REMEDIATION SYSTEM EVALUATION

BOOMSNUB/AIRCO SUPERFUND SITE
HAZEL DELL, WASHINGTON

Report of the Remediation System Evaluation,
Site Visit Conducted at the Boomsnub/Airco Superfund Site
February 26-27, 2002

EPA 542-R-02-016
September 2002
www.epa.gov/tio
clu-in.org/optimization

Concentration Contours For Chromium in Groundwater October 1995, 2001

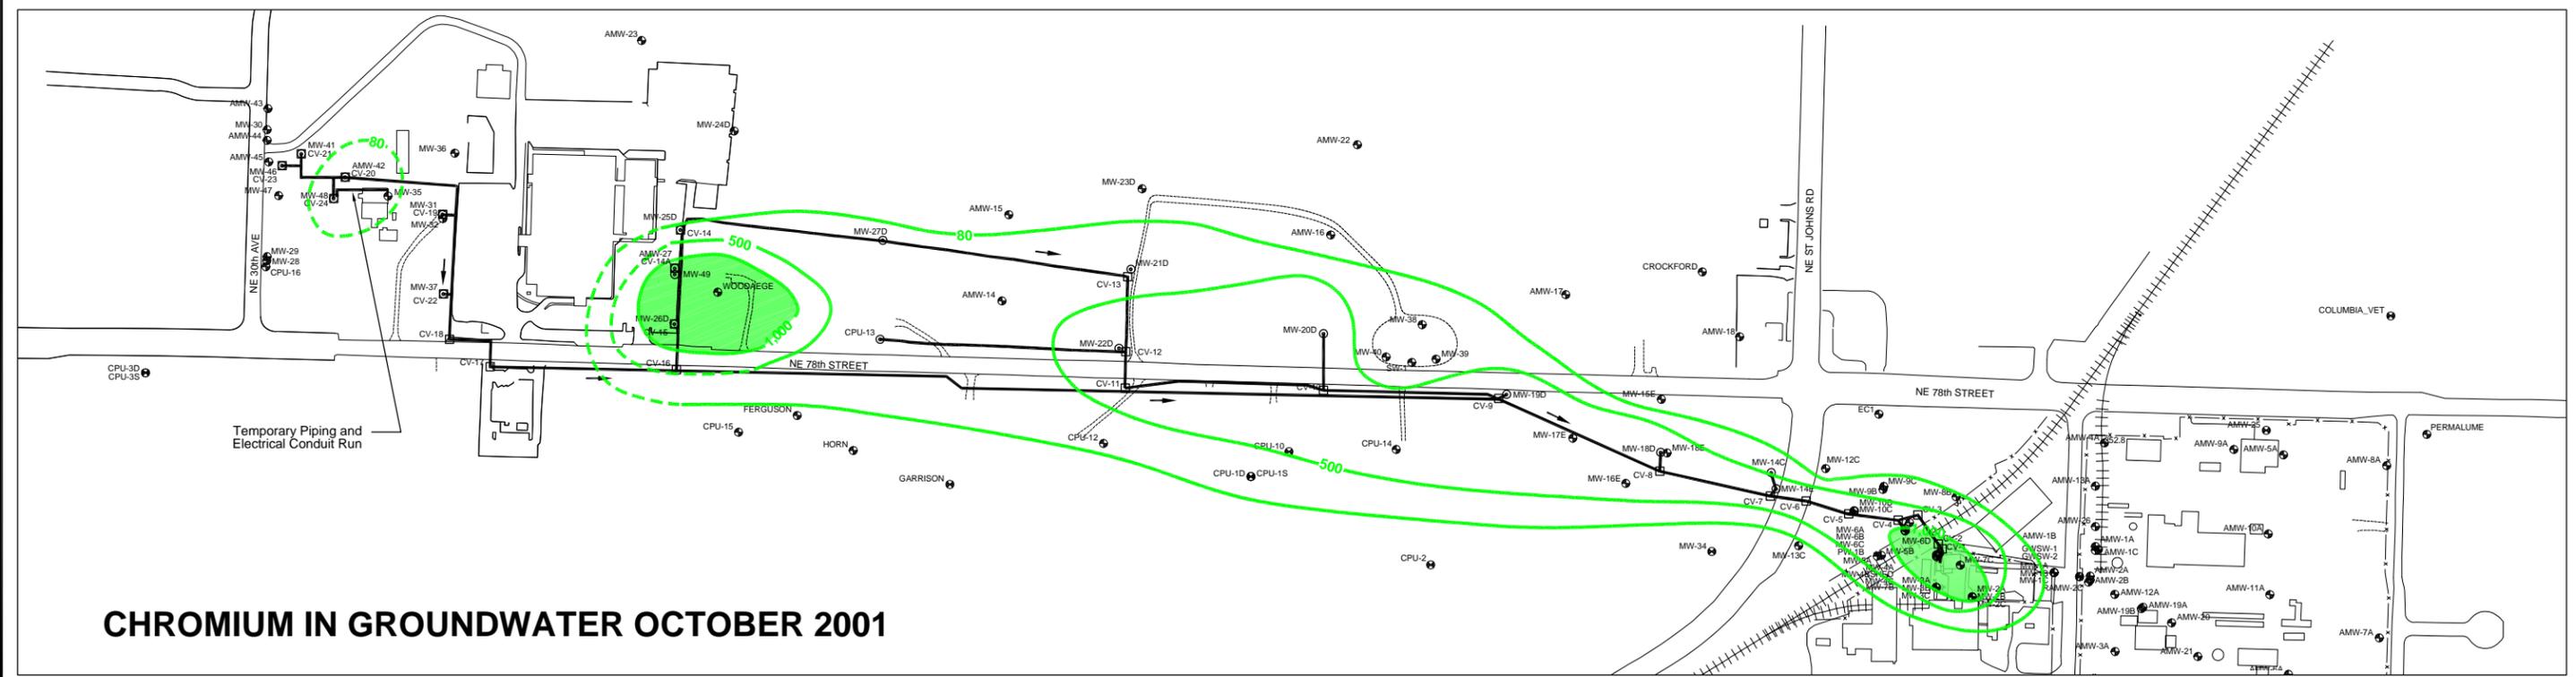
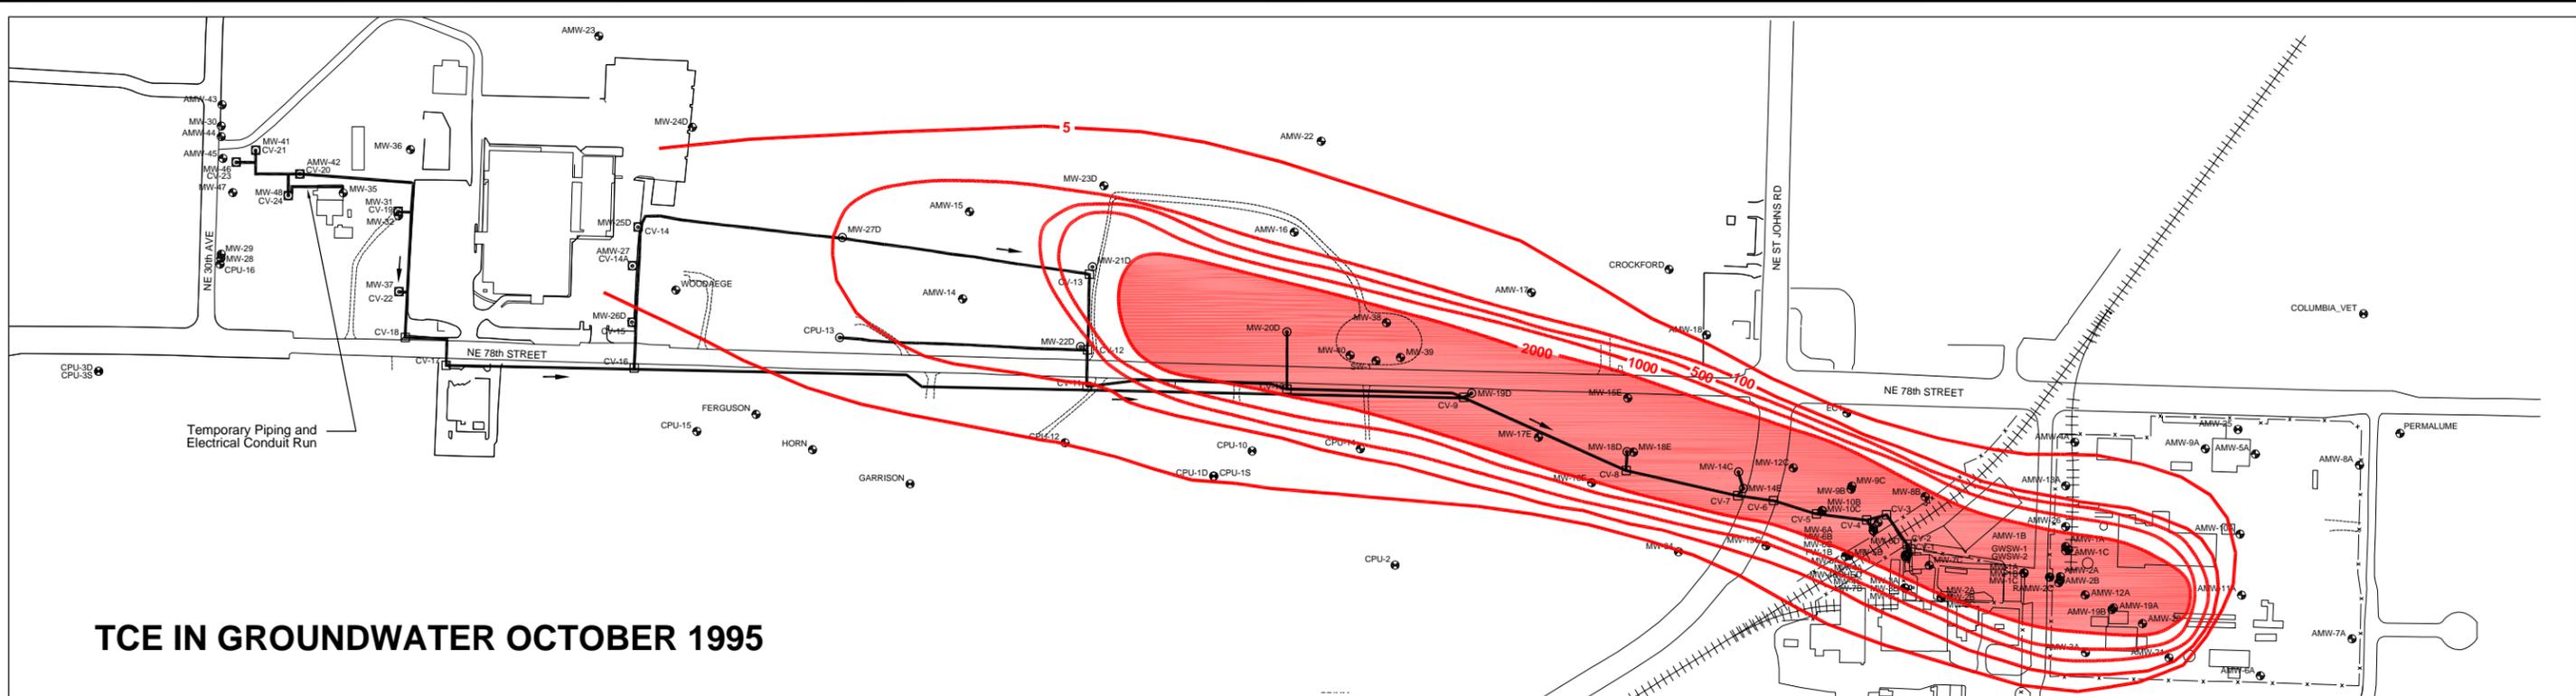
The estimated extent of the October 1995 and October 2001 chromium plumes in the Alluvial aquifer are presented in Figure 1-1, and the estimated extent of the October 1995 and October 2001 TCE plumes in the Alluvial aquifer are presented in Figure 1-2. The site team reports that since the pump and treat operation began in 1990, approximately 20,000 pounds of chromium and 1,500 pounds of TCE have been removed from ground water. The concentrations within plumes for each contaminant have decreased significantly in magnitude as a result of the pump and treat operations, but the outline or extent of the plumes have remained relatively constant.
